The Commission has issued the enclosed Amendment No. 77 to Facility Operating License No. DPR-35 for the Pilgrim Nuclear Power Station in response to your request dated March 20, 1984.

This amendment changes the Technical Specifications by extending the Power/Flow Map; requiring the rod block monitor maximum trip level to be set at 107% power for core flows of 100% rated or greater; and correcting a typographical error (from "REM" to "RBM"). These changes do not permit continuous operation at power levels greater than 100% of the present rating.

Amendment No. 77
License No. DPR-35

SUPPORTING AMENDMENT NO. 77 TO FACILITY OPERATING LICENSE NO. DPR-35

CORE THERMAL POWER MWT

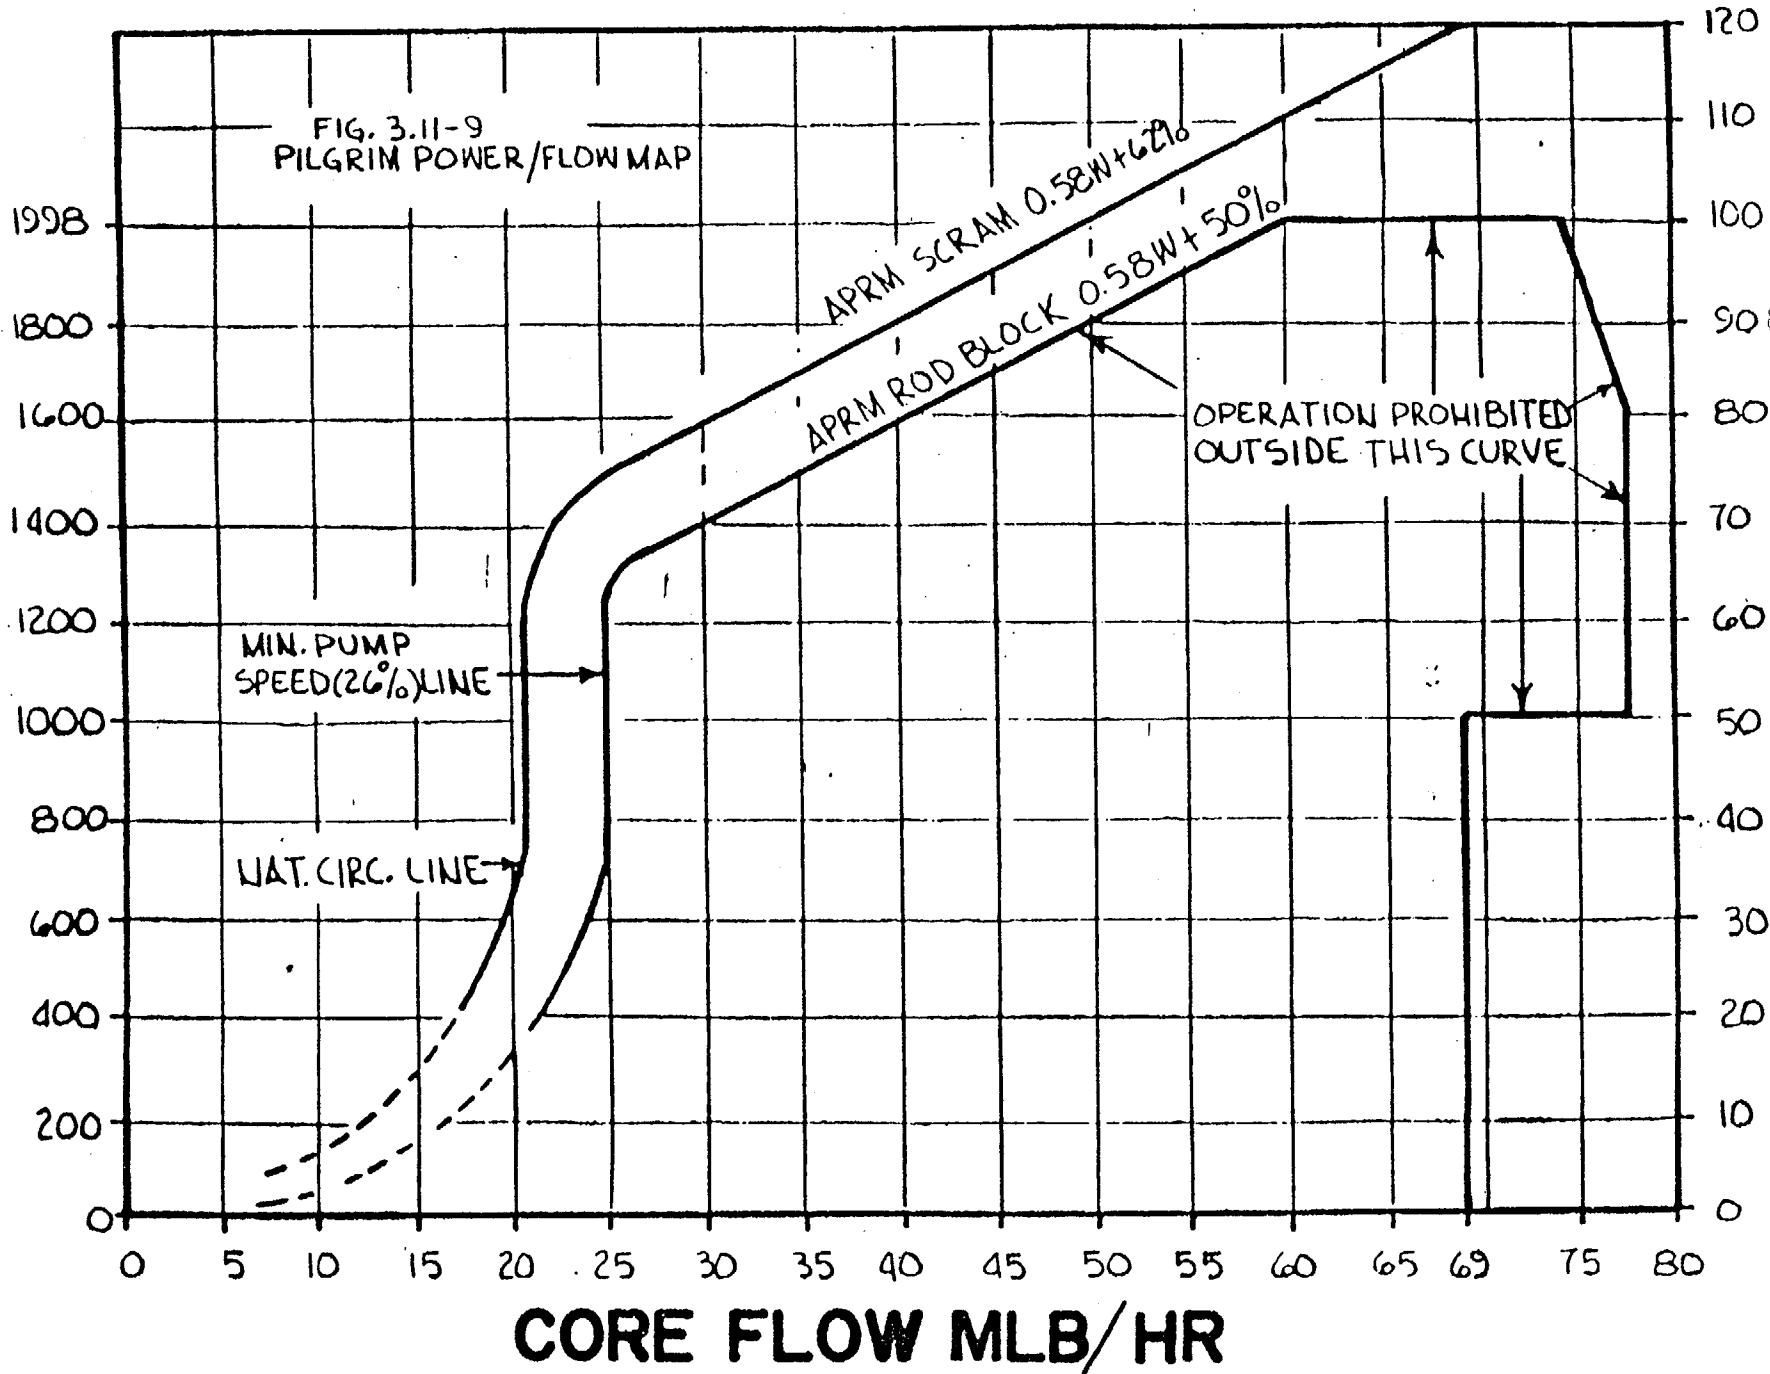
Based on our review, we conclude that clipping the Rod Block Monitor at 107% of rated power will permit the plant to be operated within the limits shown on Technical Specification Figure 3.11-9. The proposed change in footnote 2 of Table 3.2.C requires this clipping. We therefore find that the proposed changes in the Technical Specifications are acceptable.

2. W is percent of drive flow required to produce a rated core flow of 69 Mlb/hr. Trip level setting is in percent of design power (1998 Mwt). For flows of 100% or greater, the rod block monitor maximum trip level setting shall be 107% power.
